RE: JOB NO. 14046
TOWN OF TRUMBULL
MARY J. SCHERLACH COUNSELING CENTER
RENOVATIONS & ALTERATIONS
121 OLD MINE ROAD, TRUMBULL, CT

SUBJECT: ADDENDUM NO. 1

DATE: OCTOBER 20, 2014

E-4

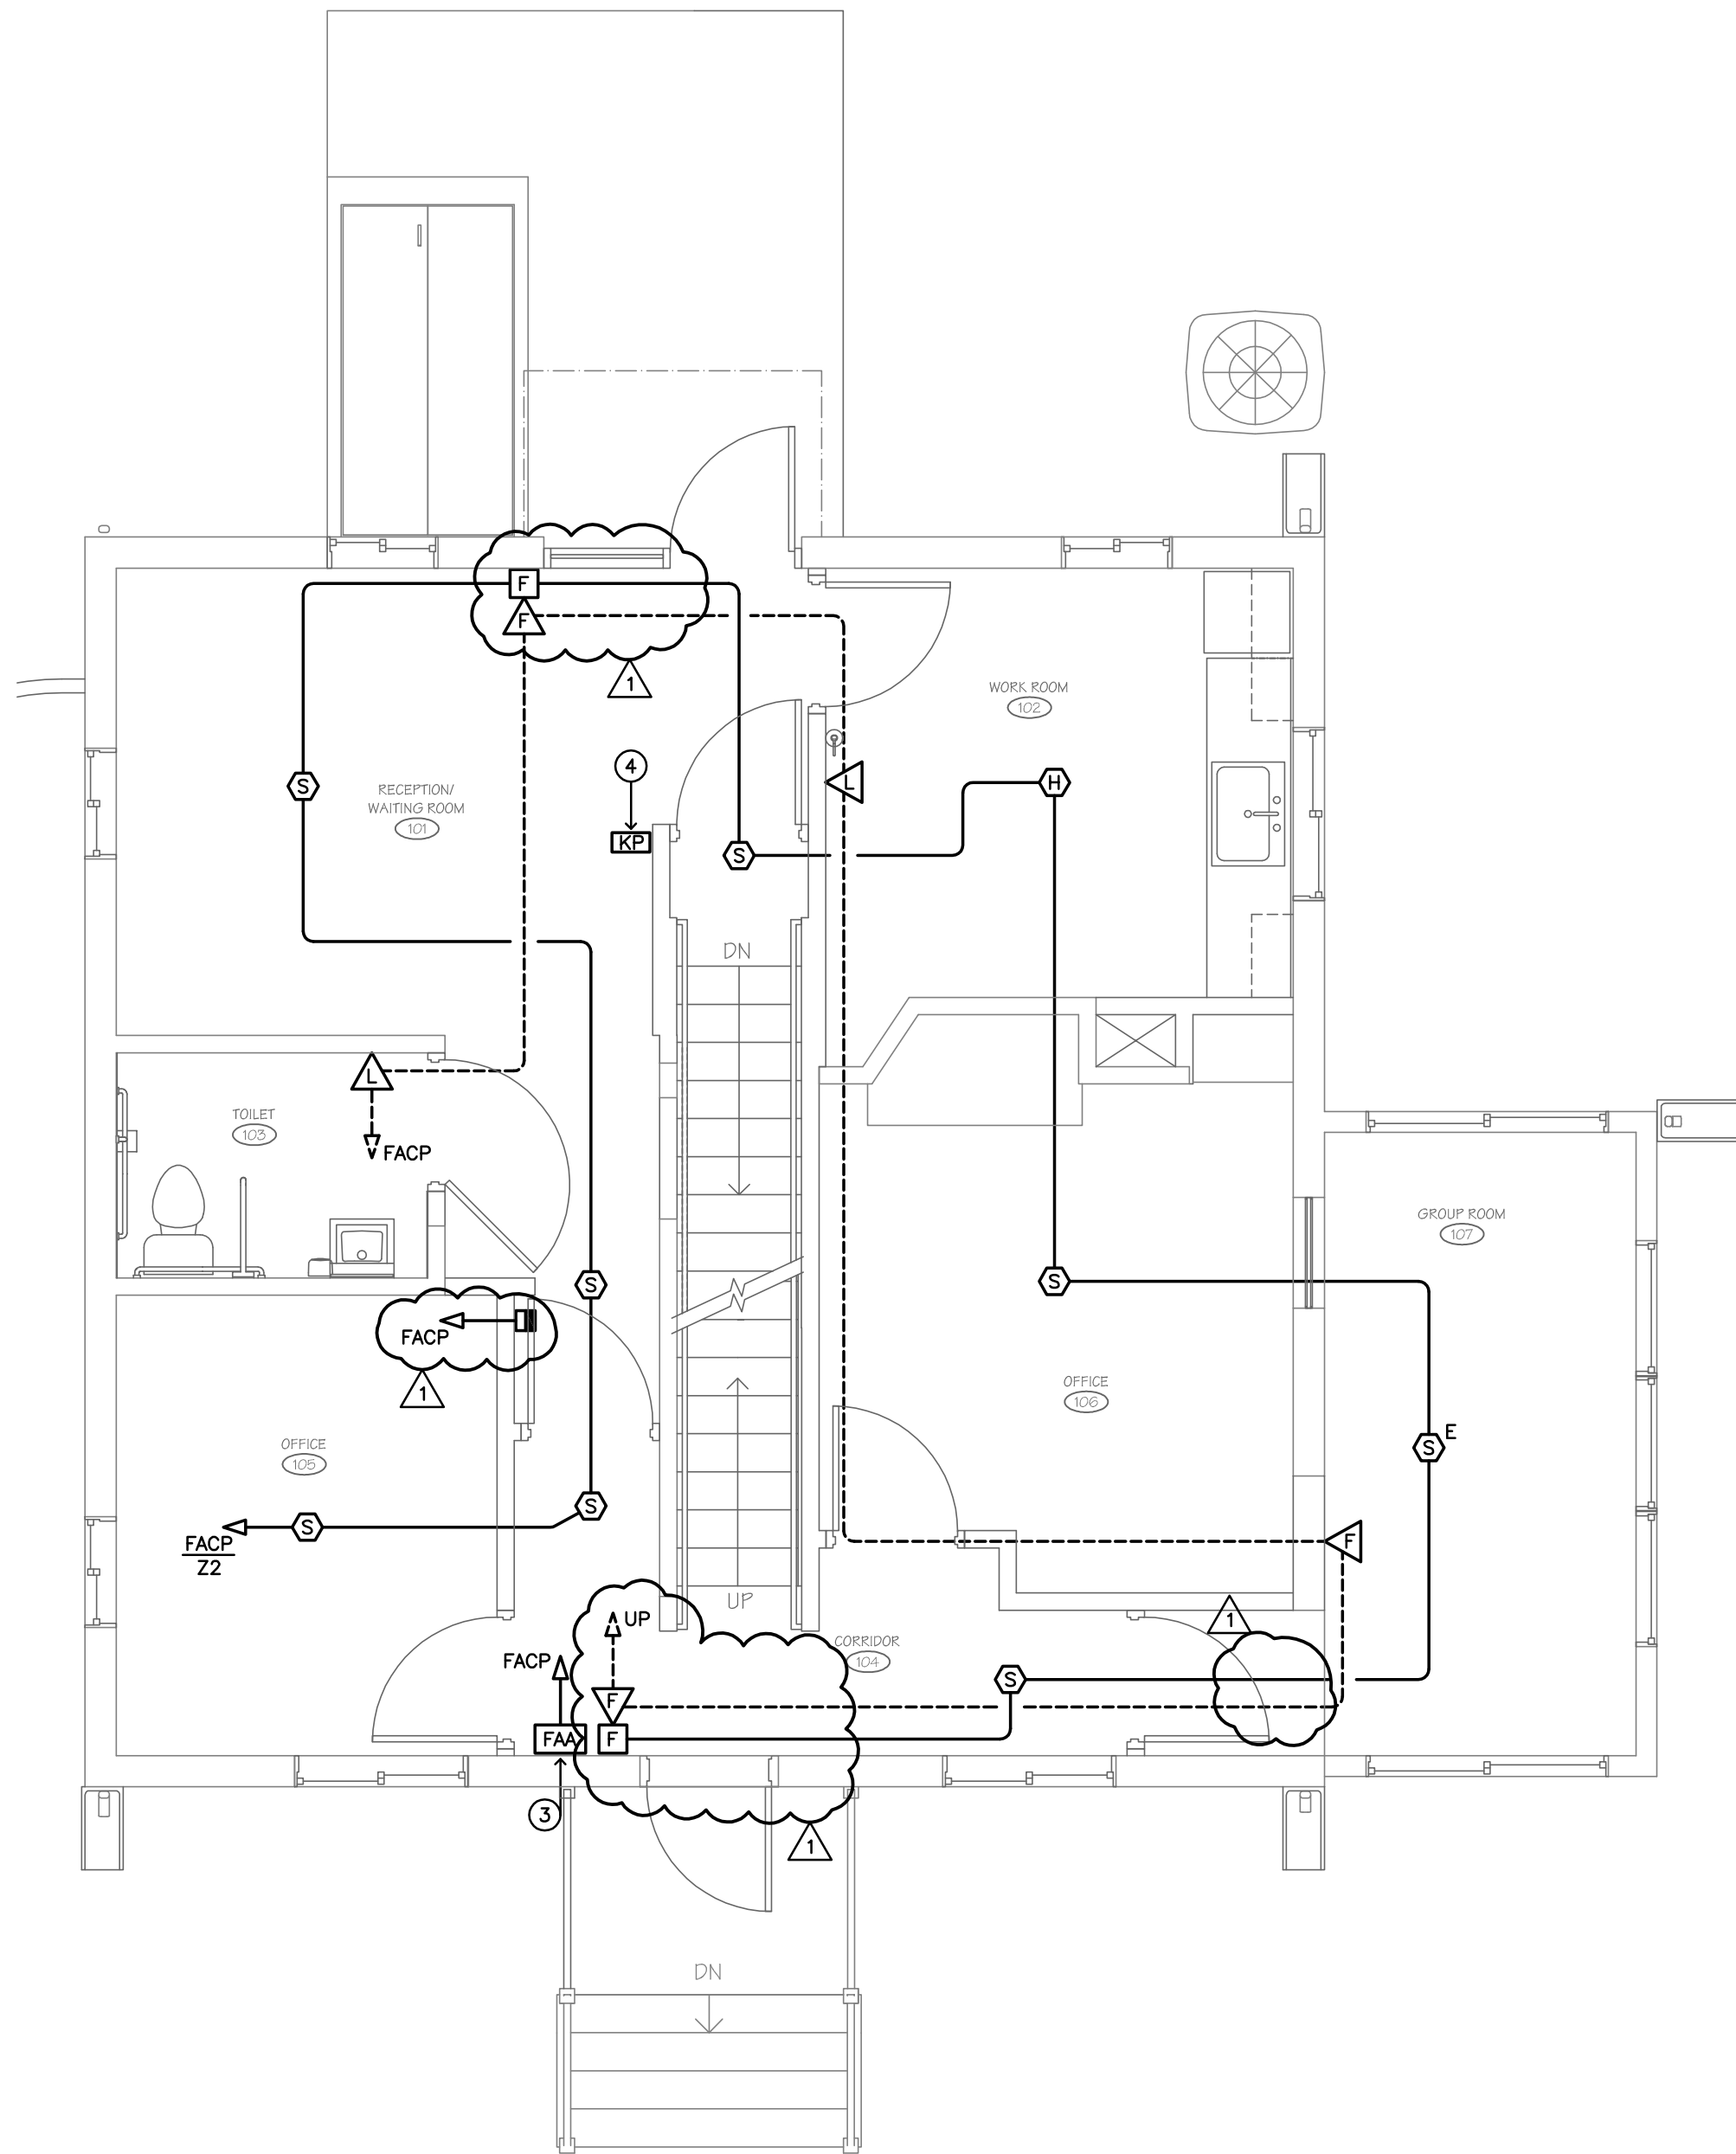
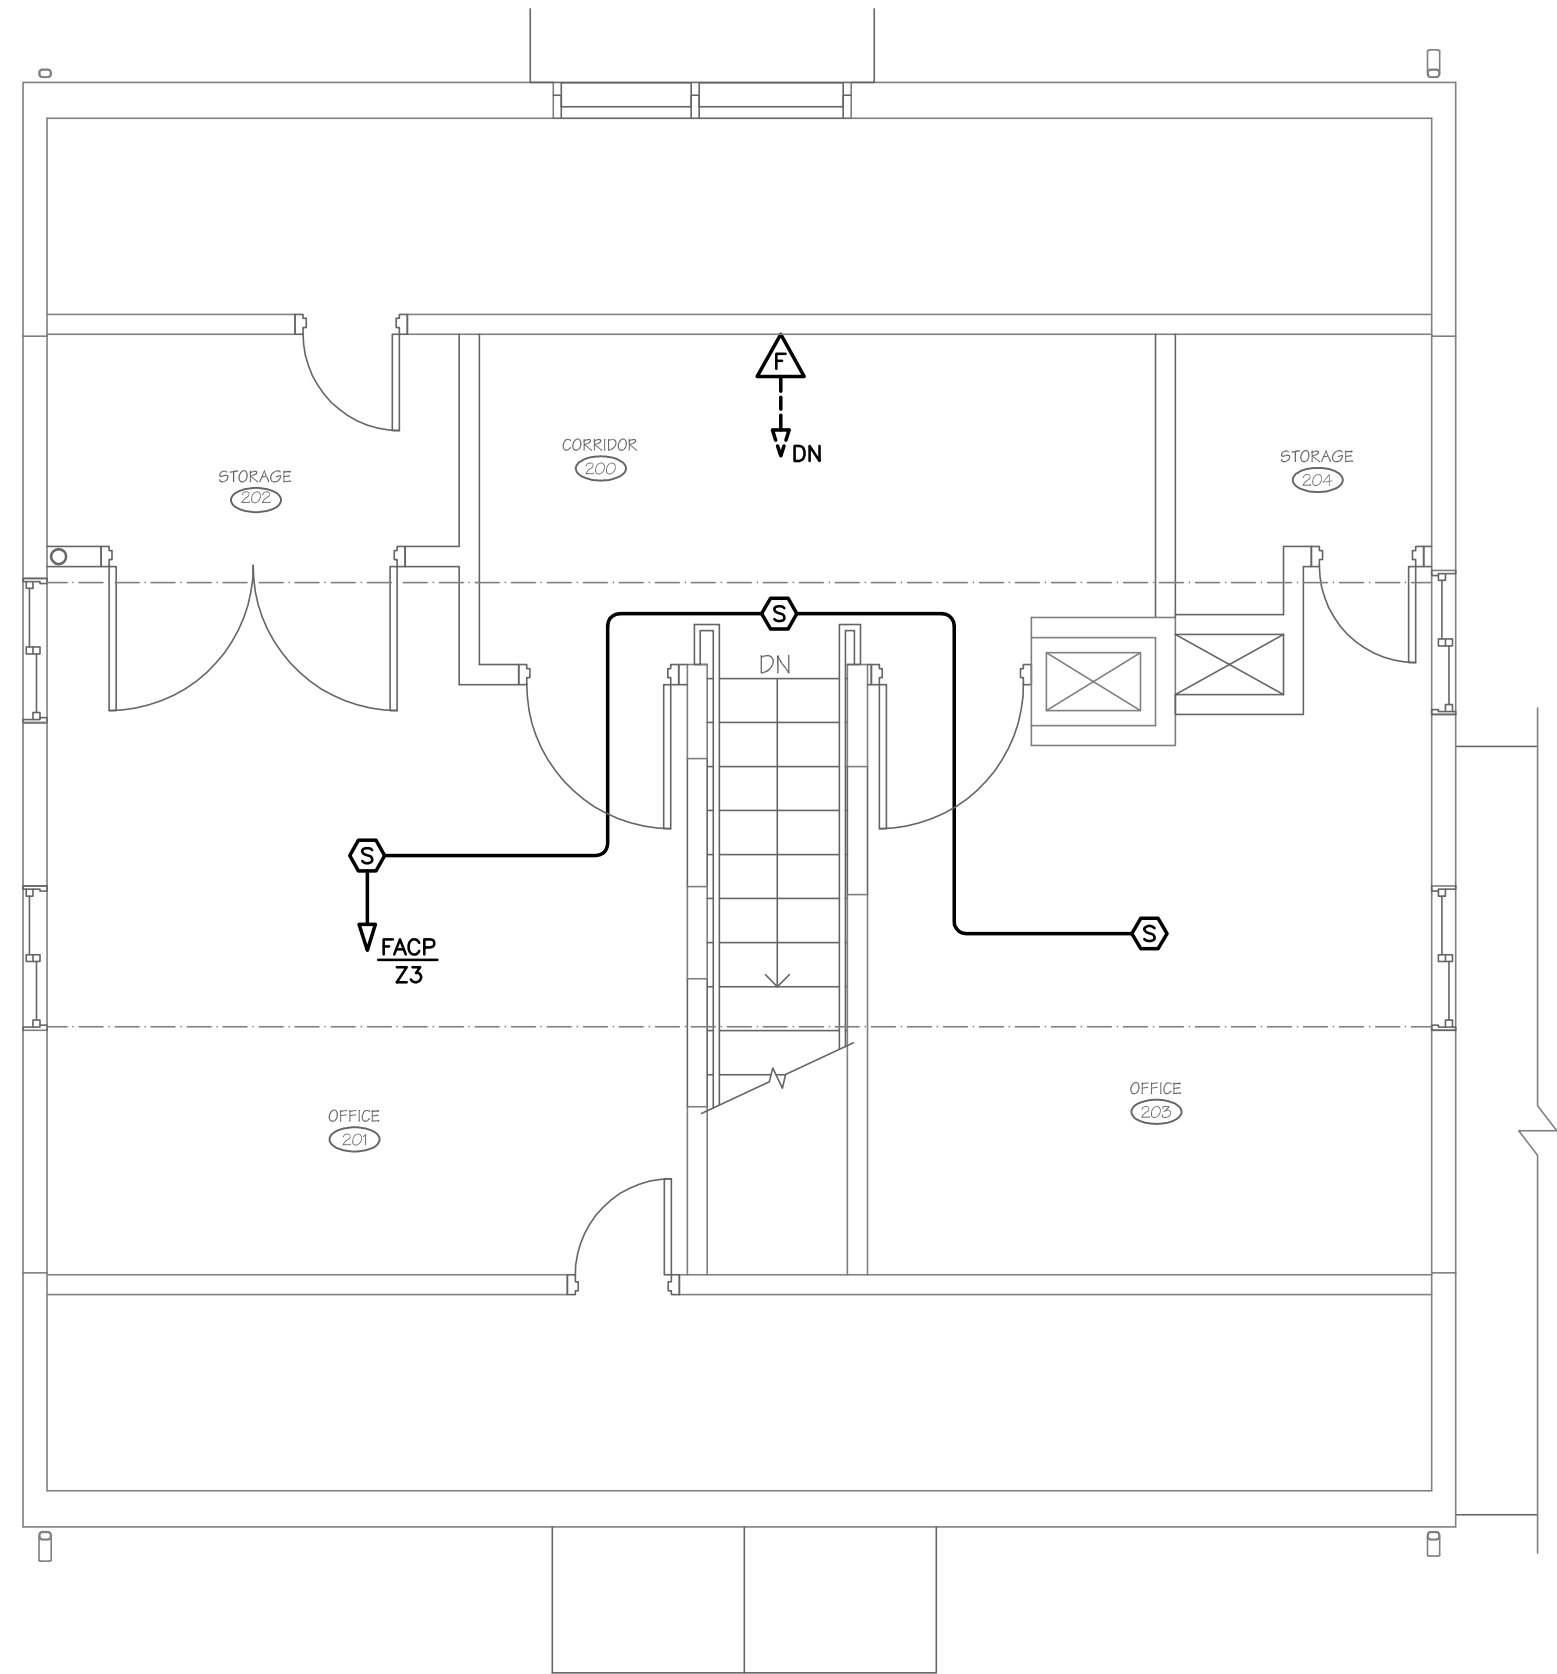
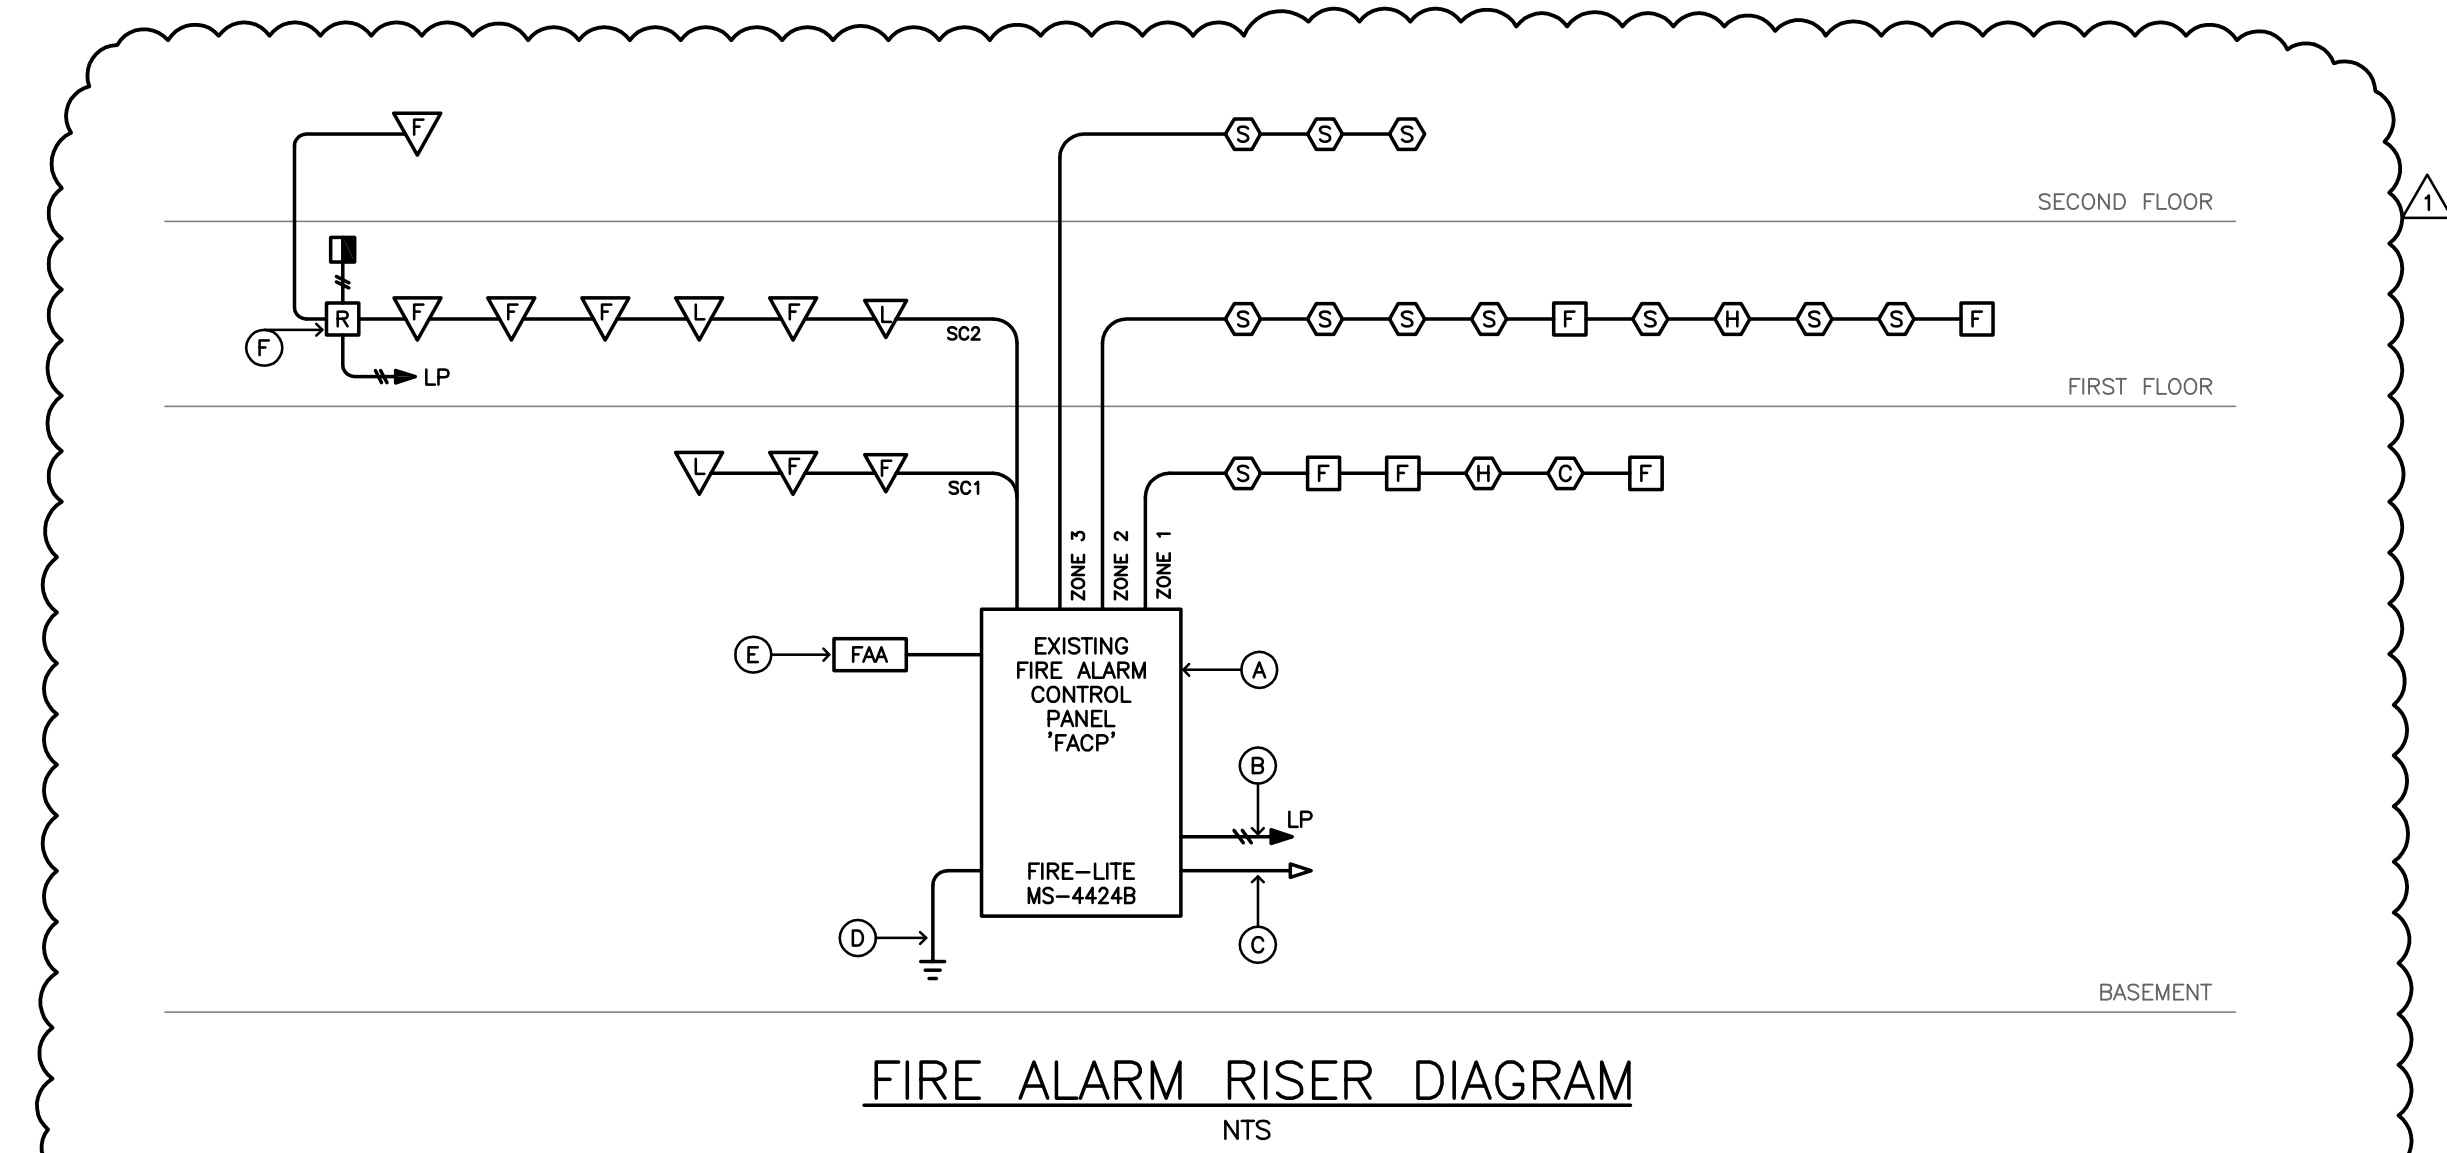
3. DRAWINGS – E-1, E-3, E-4

- A. Refer to three (3) attached revised drawings dated Revision #1 – 10-20-14.
